TRANSICOLD

K410 Identification Method

Fig 1

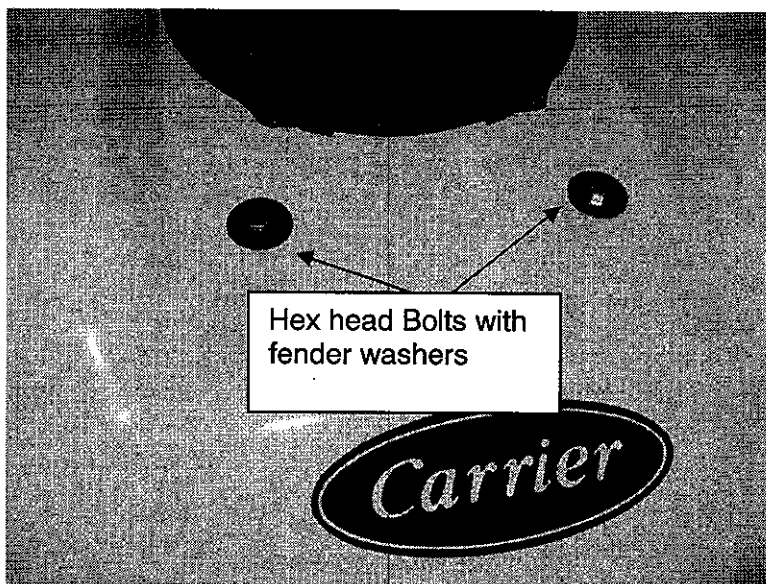
In order to check if your K410 rooftop condenser needs to be updated please look at the unit, if the cover is secured by Hex head bolts with fender washers (2 in the front and 4 in the back). Reference the Fig 1 below. If this is the case, then your unit was already retrofitted and **no further action is needed**.

Fig 2

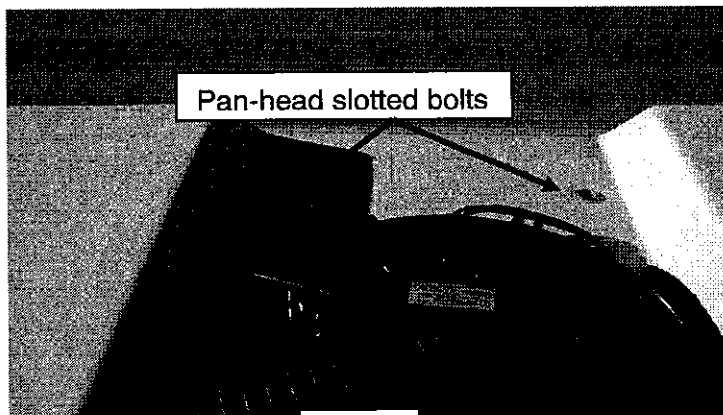
If the cover of your K410 is secured by Pan-head slotted bolts (fig 2), then it will need to have a, PN# 74-62047-00, retrofit kit installed by a Carrier authorized dealer or at your shop. Please call 1-800-450-2211 to have the retrofit kit(s) send. Carrier will pay all costs to have this kit installed on your unit(s). Please have the serial number(s) of the units(s) ready for our records.

Carrier recommends that until the K410 is modified, that the cover be removed and the high pressure switch is disconnected. (**Warning ! Do not operate the air conditioning on the bus without the K410 cover secured on the unit**). The cover should be stored in a safe place until retrofit kit can be properly installed and the cover replaced.

Fig 3

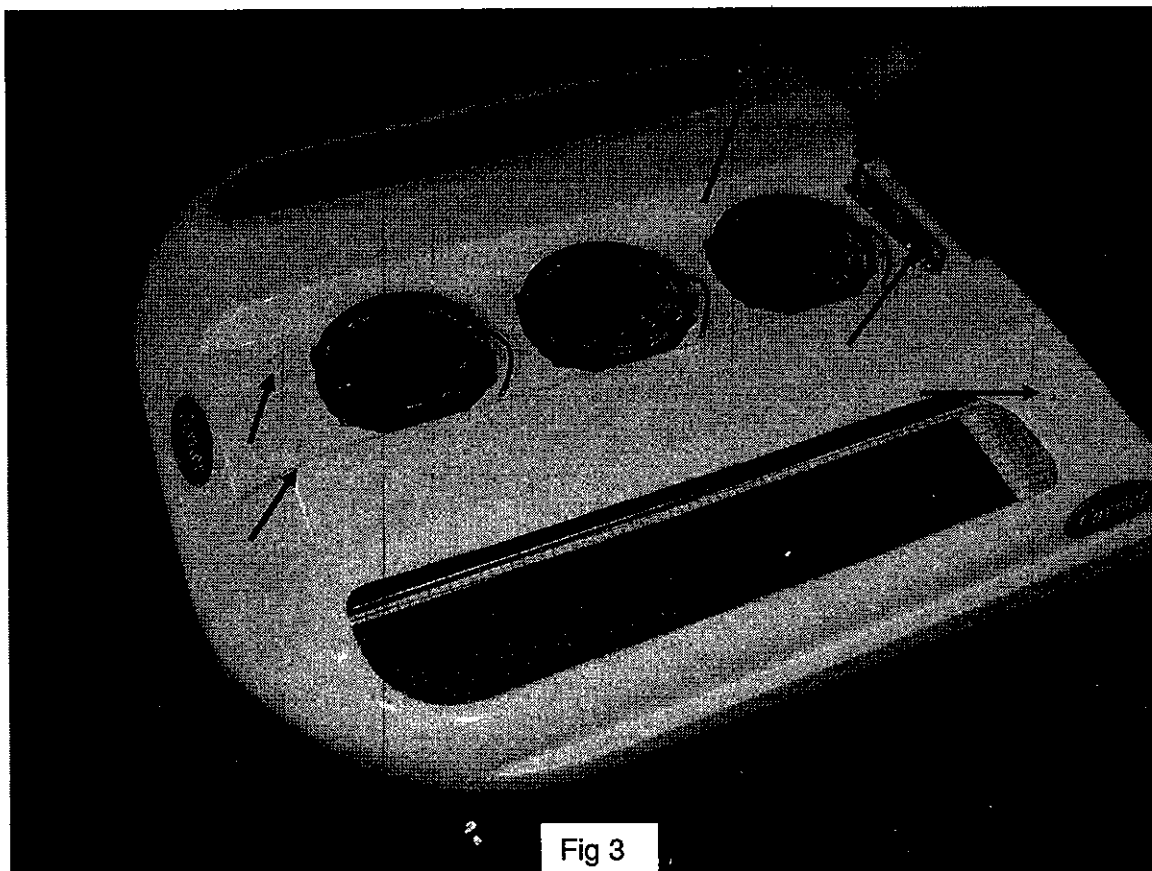
Remove 6 bolts, locations as seen in fig 3, lift cover and unplug 3 fan connectors, remove cover and store in a safe place until retrofit kit can be installed.

Fig 4

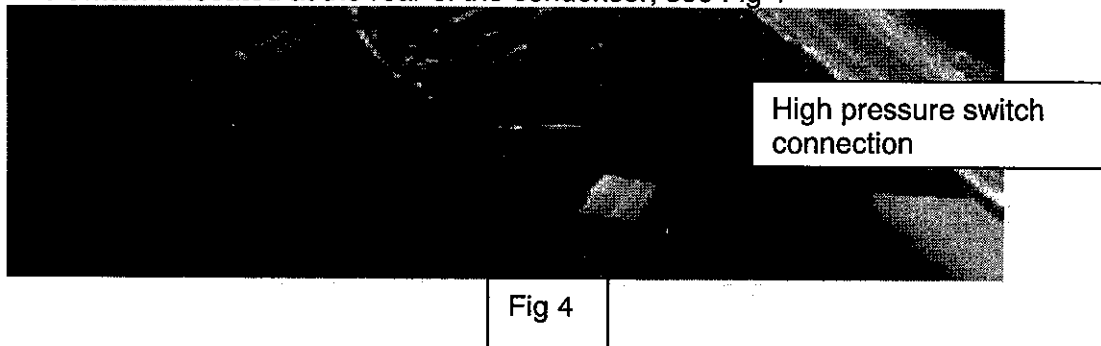
High pressure switch must be disconnected if bus is to be operated without the cover.
The switch is located at the rear of the condenser, see Fig 4
